RECOMMENDATION: The proponent is required to ensure it has adequate water supply prior to production.

RECOMMENDATION: The proponent should confirm that the identified water entitlements are available for the project and will not be required to account for continuing take where nominated. We recommend that Table 6-1 (Appendix 6 of the EIS) is updated showing all WALs held in each water source, clearing detailing which project(s) each WAL applies to, and where a WAL is being counted against multiple projects how much of the total is allocated to each project.

Figure 1

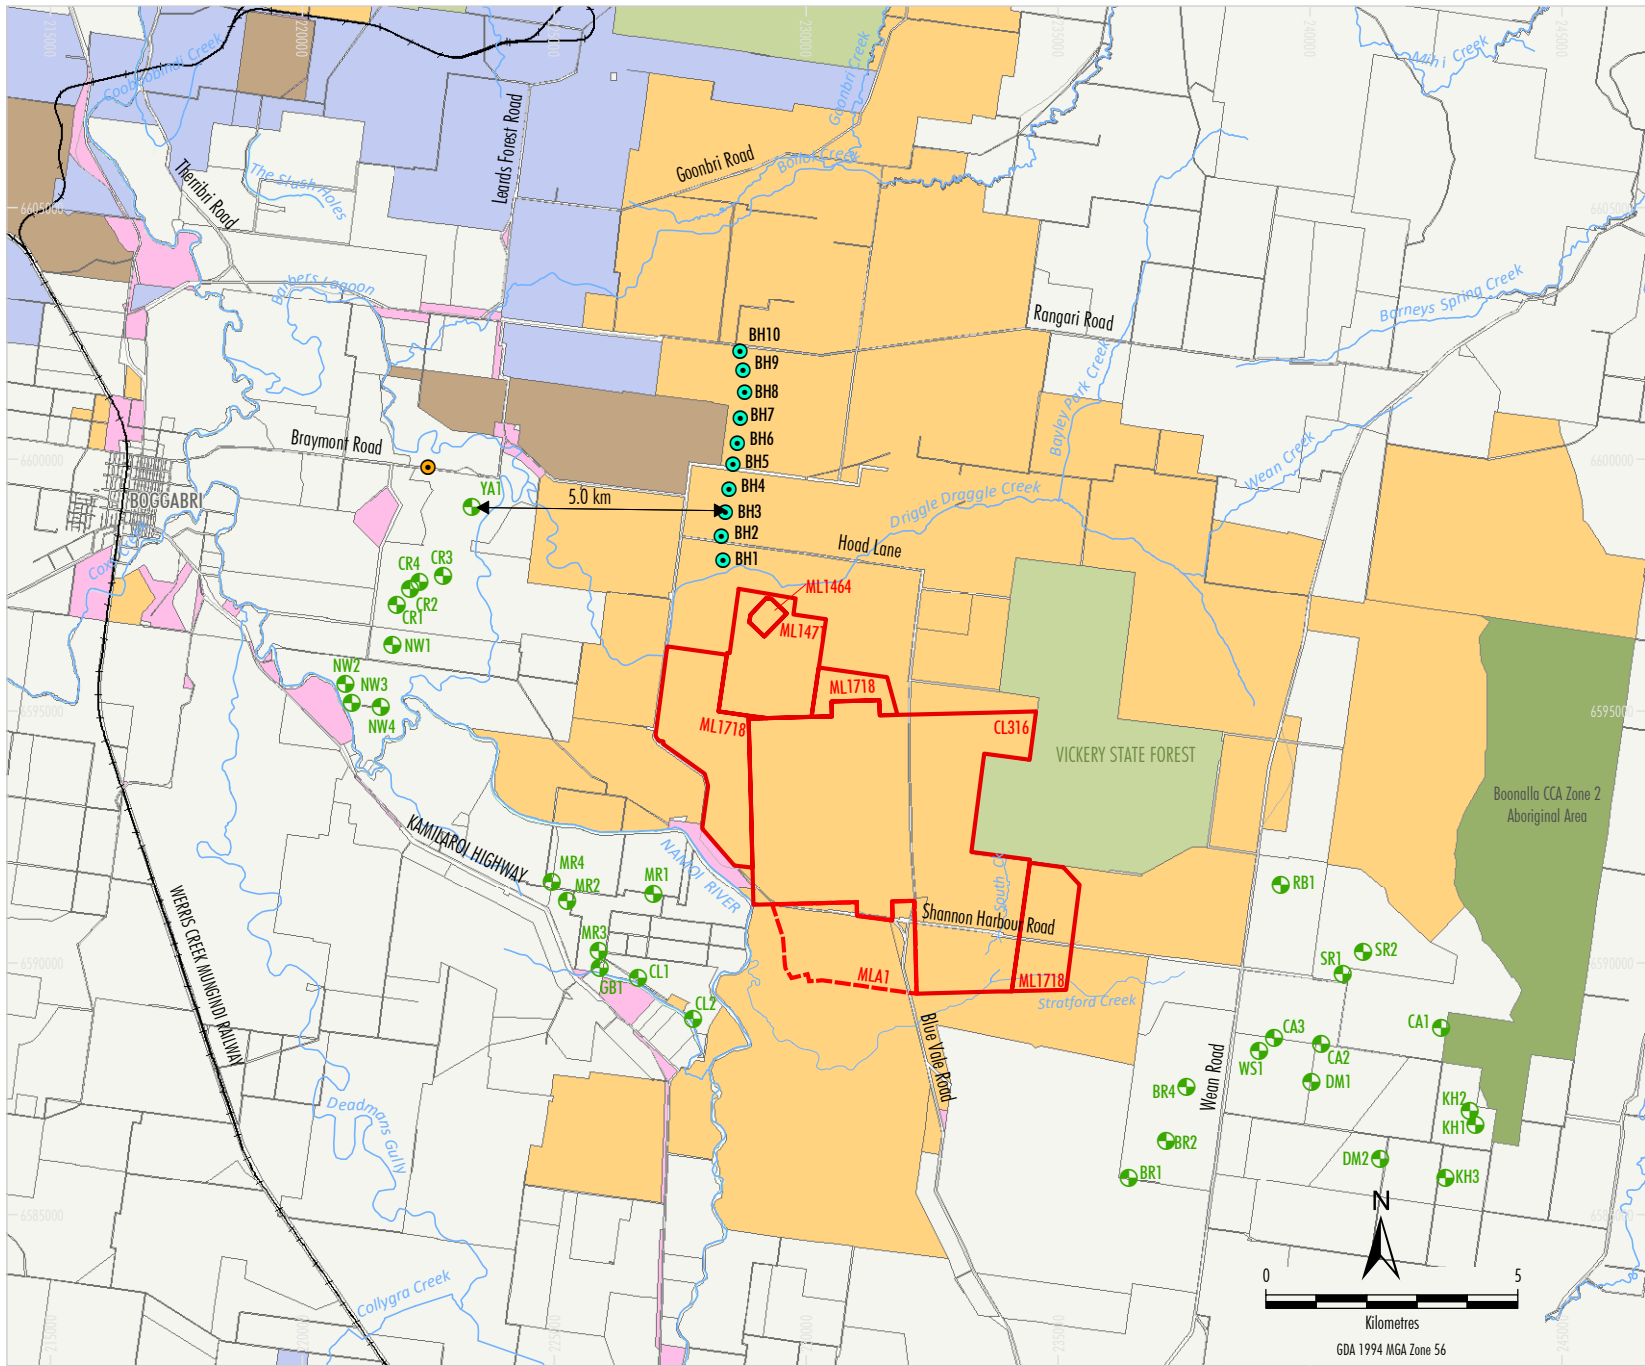
RECOMMENDATION: An impact assessment of the borefield is required against the DPIE Water groundwater dealing/new bore impact assessment criteria in consultation with DPIE Water.

The Groundwater Assessment (Appendix A of the EIS) modelled the Project borefield cumulatively with proposed and existing mining, with predicted impacts demonstrated to comply with the NSW Aquifer Interference Policy Level 1 ‘minimal impact’ criteria. In addition, positioning of the bores would be consistent with the requirements of Clause 36 of the *Water Sharing Plan for the Upper and Lower Namoi Groundwater Sources 2003*. Figure 1 shows the proximity of the Project borefield to privately-owned bores. The closest privately-owned bore (YA1) is approximately 5 kilometres away.

Notwithstanding, assessment of the Project borefield has also been conducted against the *Water Resource Plans Fact Sheet - Assessing Groundwater Applications* criteria for two modelling scenarios (Table 1):

- **Scenario 1** (EIS modelling) – modelling the proposed borefield as ten bores pumping at a combined rate of 600 ML/year (each bore pumping at a rate of 0.164 ML/d) over the 25-year Project life (as in the EIS).
- **Scenario 2** – the same total extraction volume over the life of the Project as Scenario 1, however, with pumping from only two bores (BH3 and BH5) at a rate of 3.0 ML/d each, in years 1, 5, 9, 13, 17, 21 and 25 of the Project life to reflect the expected use of borefield intermittently as a backup up water supply (as per its predicted use in the Site Water Balance).

Figure 3

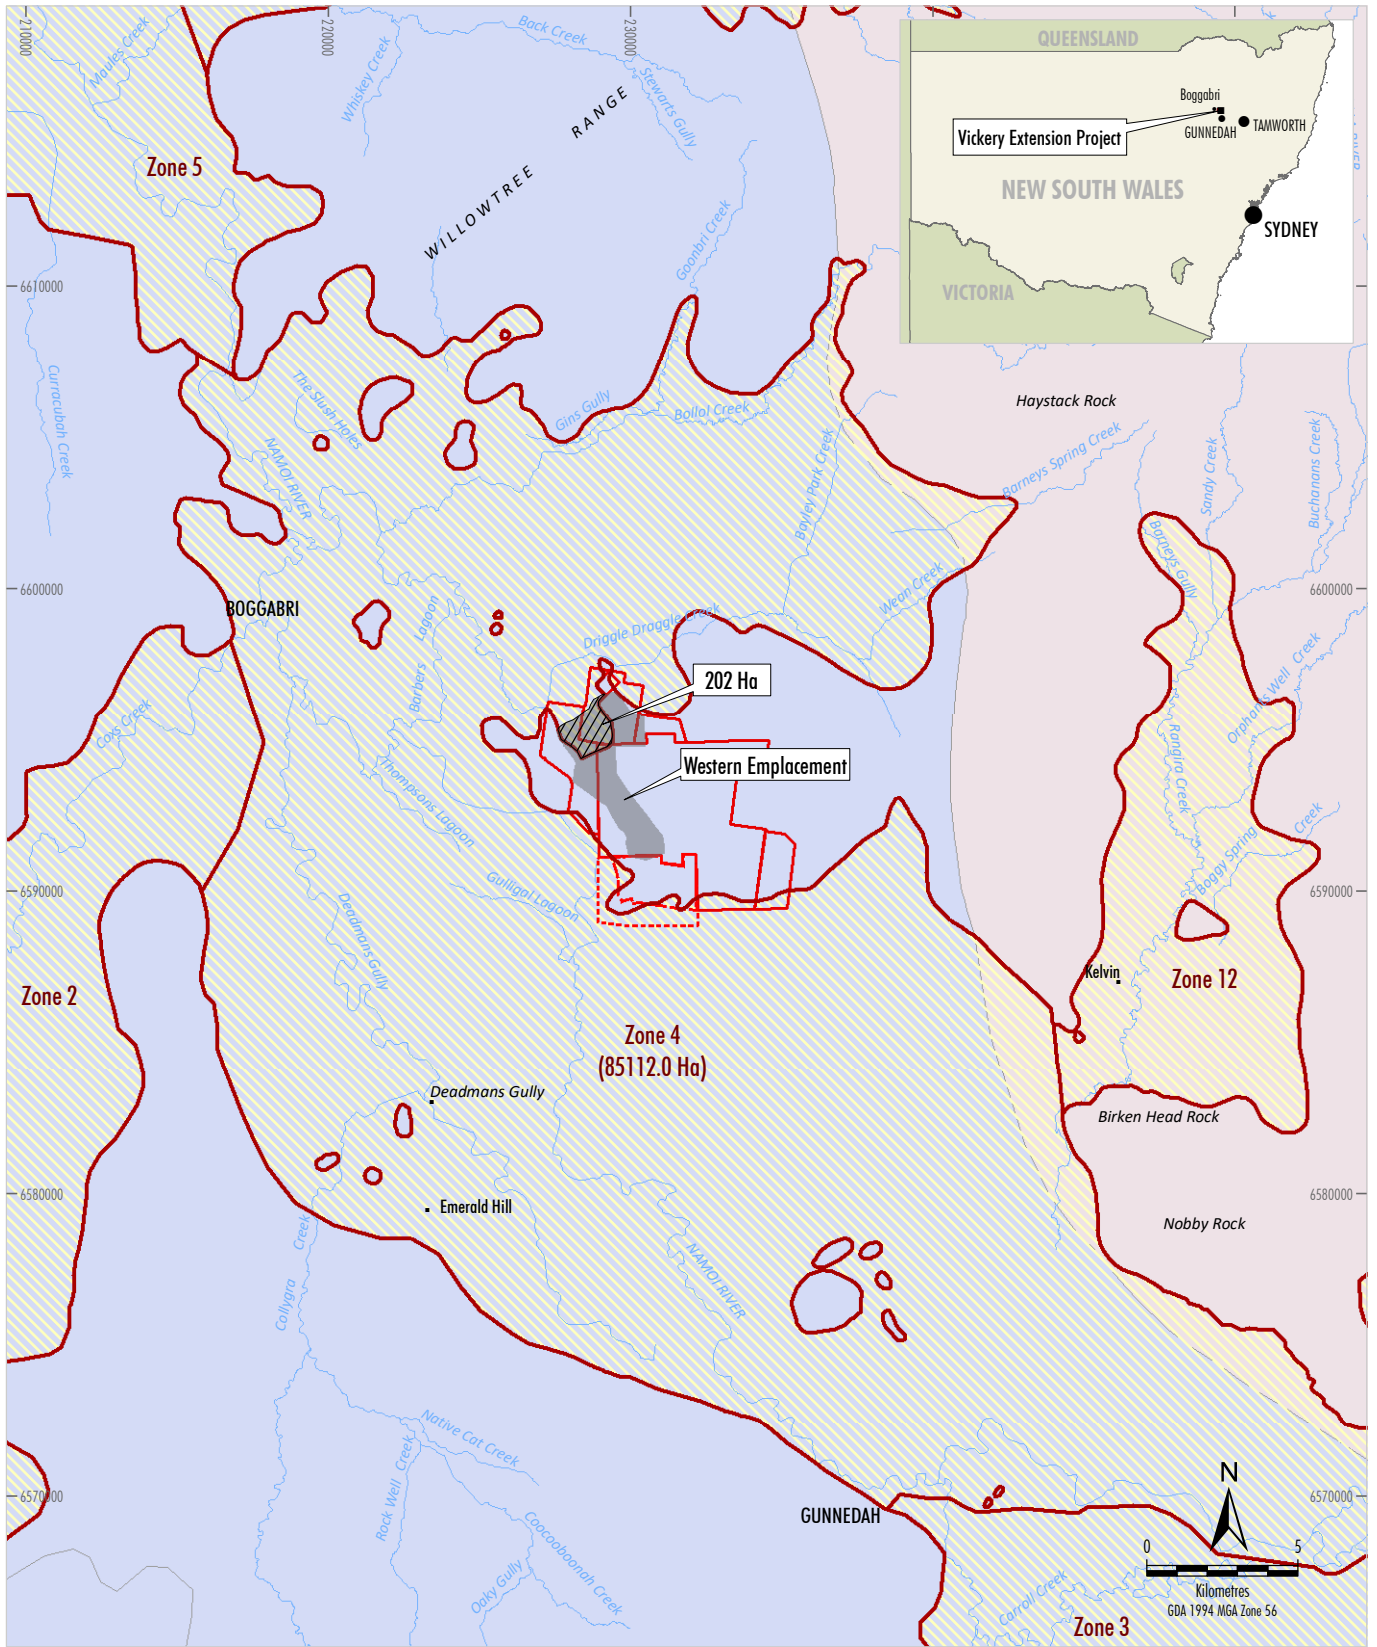
RECOMMENDATION: With respect to the stockpile -

- **The proponent is required to map the proposed stockpile locations in relation to the alluvial boundaries. Figure 3 in the RTS must be updated with this information.**
- **The proponent is required to address compaction of the alluvium in relation to extent and loss of storage.**
- **The proponent is required to address water quality risks including baseline, lateral extends, duration, risk to receptors to the alluvium as a result of the emplacements that overlie or are adjacent to the alluvium.**
- **The proponent is required to clarify any measure in place to mitigate the risk of the stockpile to the alluvium.**

Please refer to Figure 3 for the alluvial boundaries and the Western Emplacement.

Approximately 202 ha of the proposed waste emplacement will overlap a thin clay-dominated alluvium embayment (approx. 30 m thick) to the north-west of the open cut and adjacent to Canyon Coal Mine (refer attached Figure 3).

This equates to approximately 0.2% of the total area of the Upper Namoi Zone 4 alluvium groundwater source.

The alluvium that the emplacement would overlap has been impacted by the existing Canyon Coal Mine final void.

Any increase in density of the aquifer, which would be minimal in any event, would occur in the area bordering the Maules Creek Formation and would not have a material effect on the remaining Zone 4 alluvium. Therefore, effects of the overlapping emplacement to regional groundwater storage or flow would be negligible.
